NL-04-0473

Joseph M. Farley Nuclear Plant Units 1 and 2
Application for License Renewal –
Requests for Additional Information (RAIs)

Responses to March 8, 2004 Requests for Additional Information

In response to the staff's request, Figure 2.3.4.4-1, "Turbine Driven AFW Pump Turbine Lube Oil Piping Schematic", was developed to identify the components of this subsystem and to present SNC's scoping results in accordance with the requirements of 10 CFR 54.4(a).

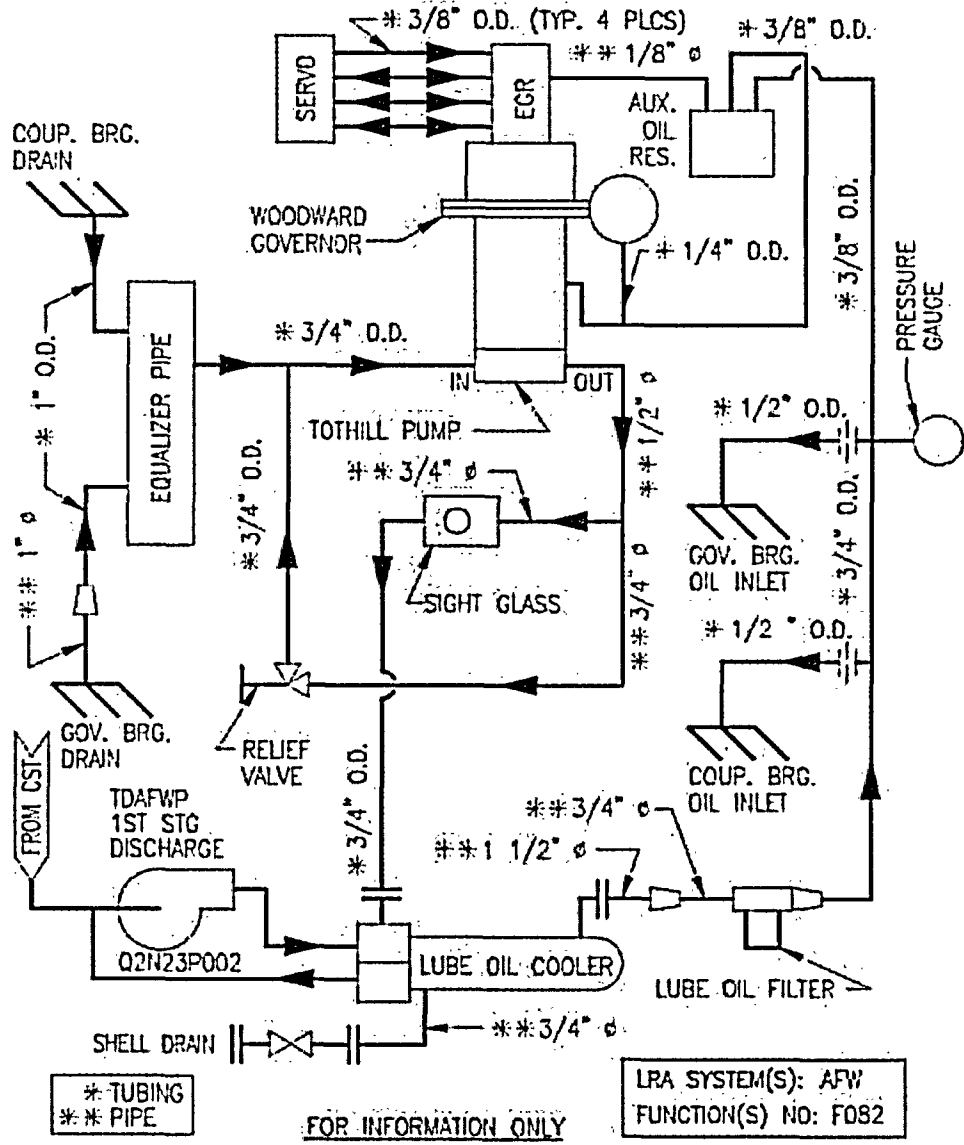
LRA Table 2.3.4.4 lists the components of the AFW system that are subject to an AMR. Some items included are: Filters (casing), Oil Cooler (shell), Oil Cooler (channel head), Oil Cooler (tube sheet), Oil Cooler (tubes). These components comprise part of the turbine lube oil subsystem. The AFW pump and its turbine drive are shown on license renewal boundary drawings D-175007L and D-205007L (location H5 on both drawings) and also on D-175033L and D-205033L (Sheet 2, location E3 on both drawings). However, the turbine lube oil subsystem and its components are not shown on these drawings.

Identify which cooling water system is used to cool the lube oil in the heat exchanger. Confirm that all components of the turbine lube oil subsystem (AFW system) are within the scope of license renewal and subject to an AMR in accordance with the requirements of 10 CFR 54.4(a) and 54.21(a)(1), respectively; or provide drawings which show the turbine lube oil subsystem and all of its components, and identify those components considered to be within the scope of license renewal and subject to an AMR.
